**NOTICE OF ADDENDUM
ADDENDUM 1**

**CONTRACT NO. 7439
POTTER STREET RECONSTRUCTION ASSESSMENT DISTRICT 2015**

PAGE RG-1

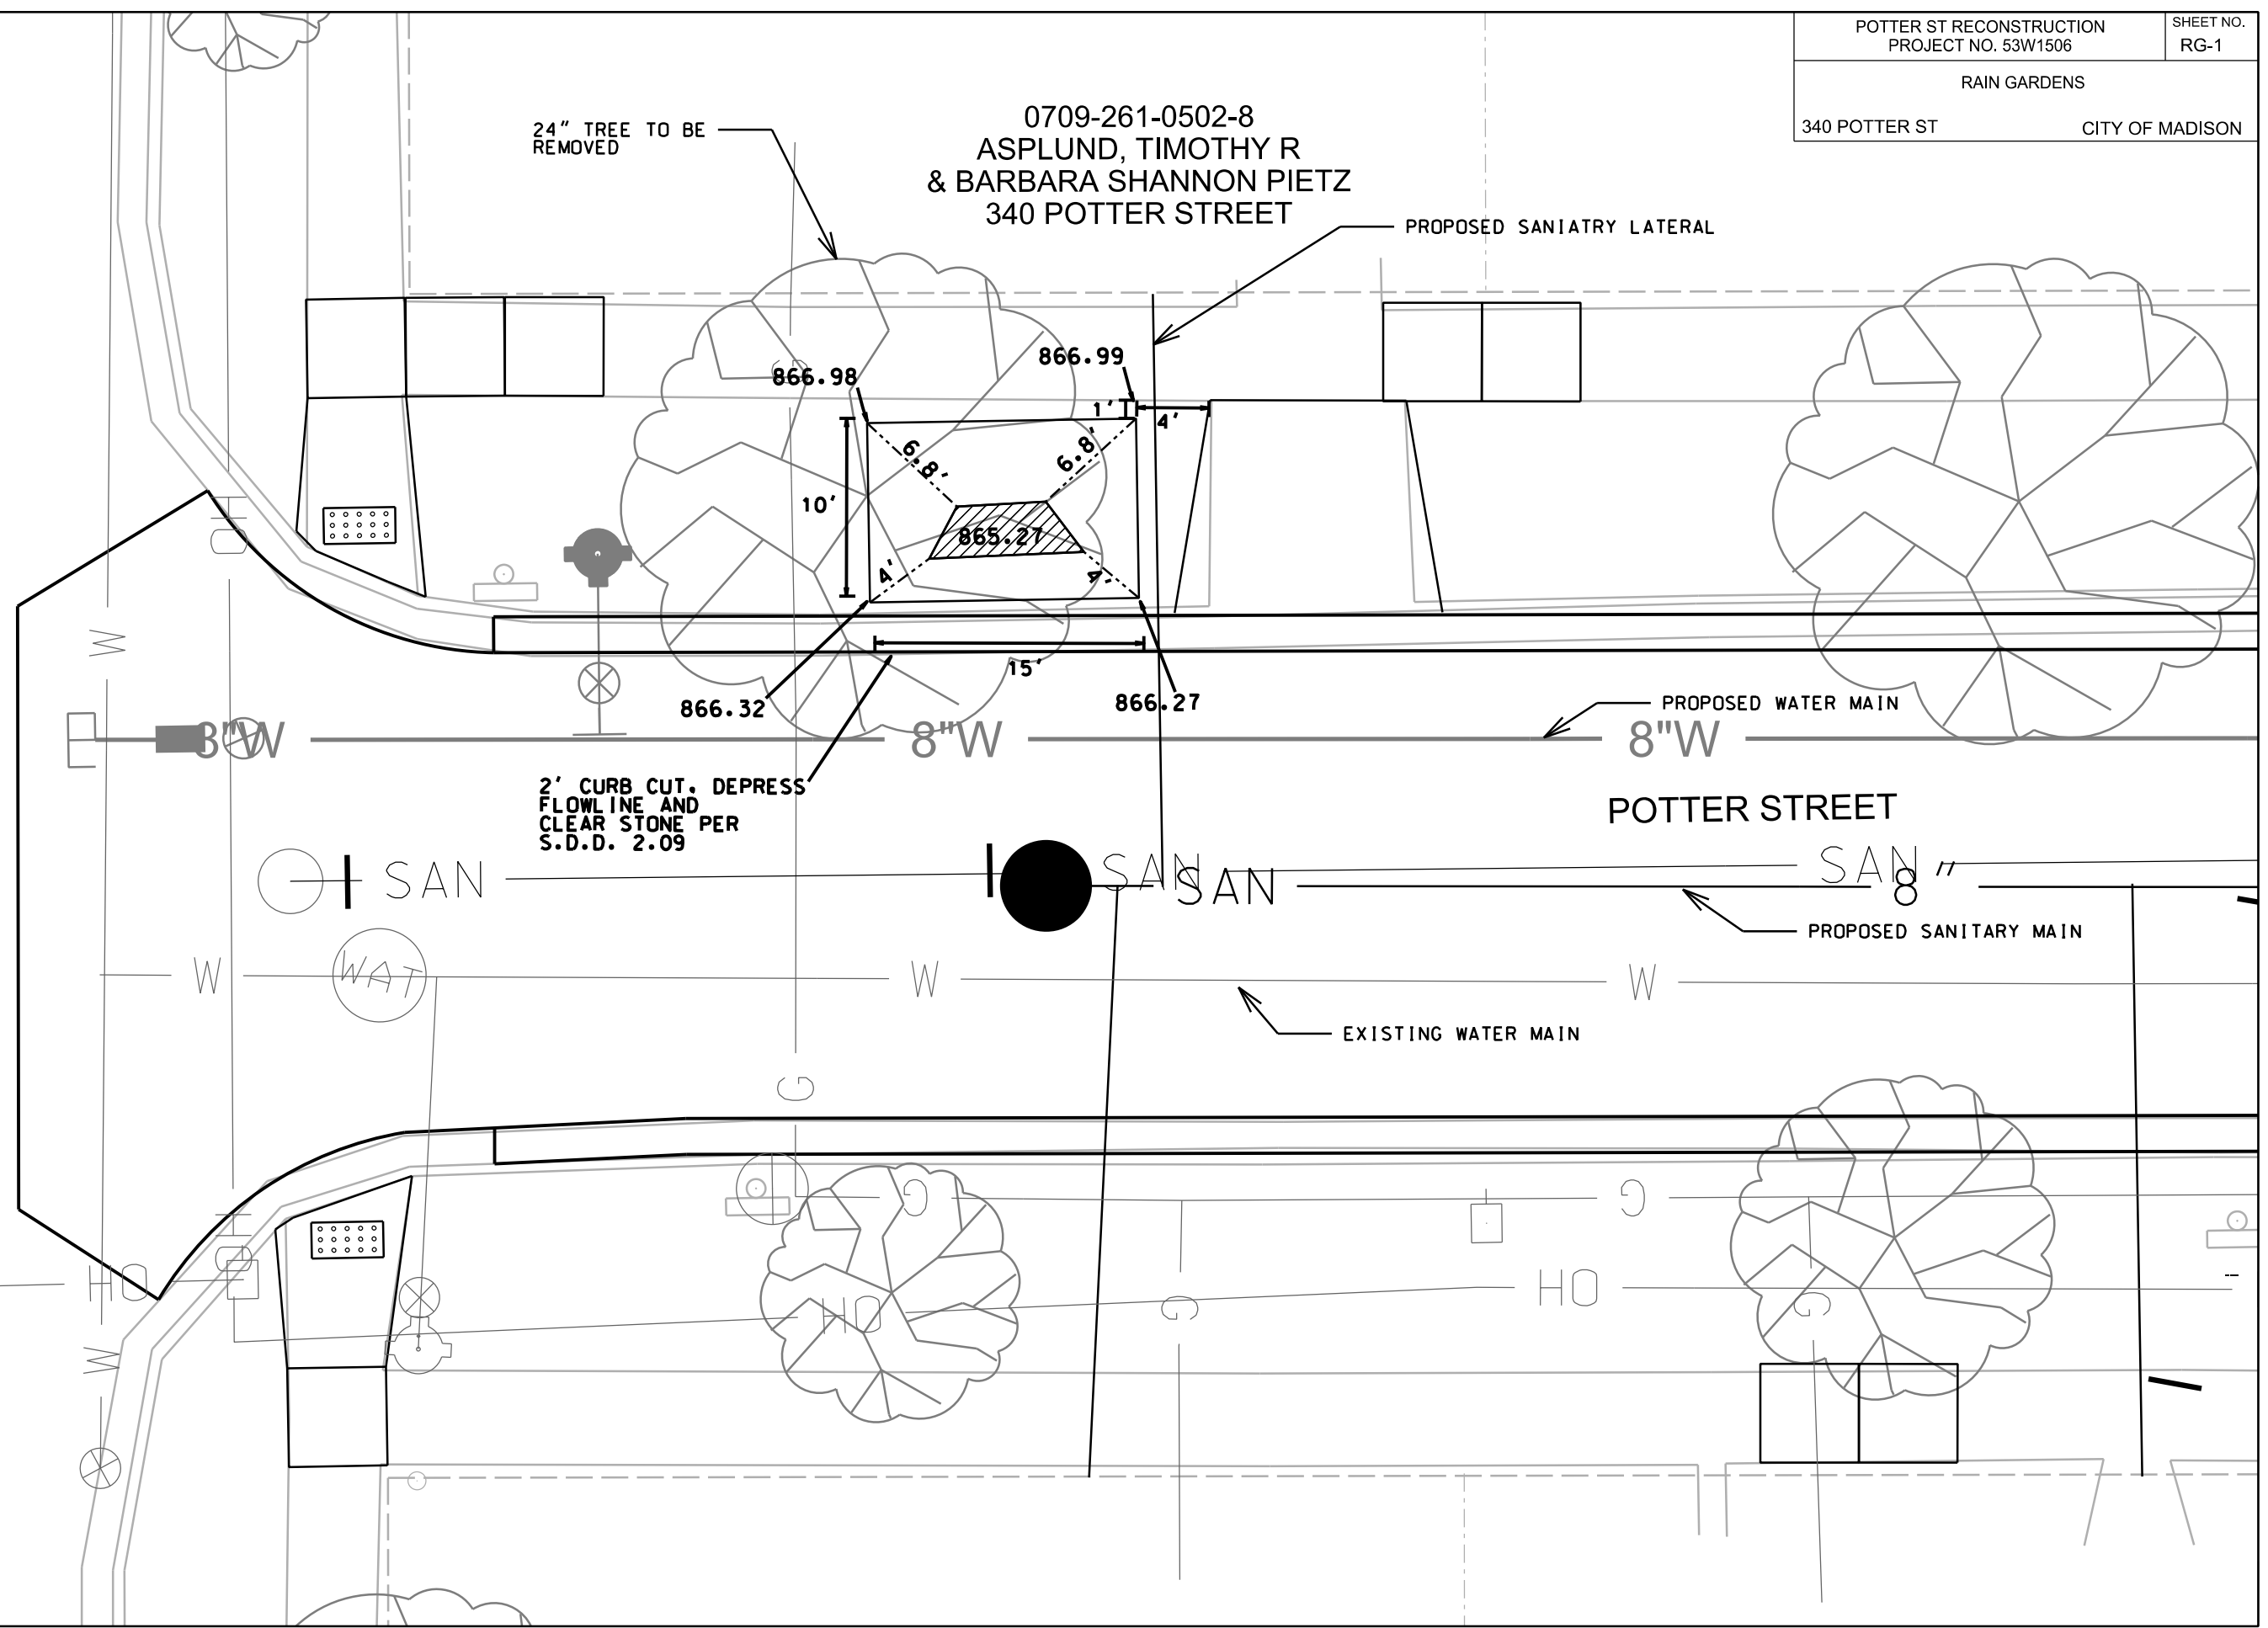
BID ITEM 21110 - RAIN GARDEN 150 S.F.

1. Add the following items to the plan set:
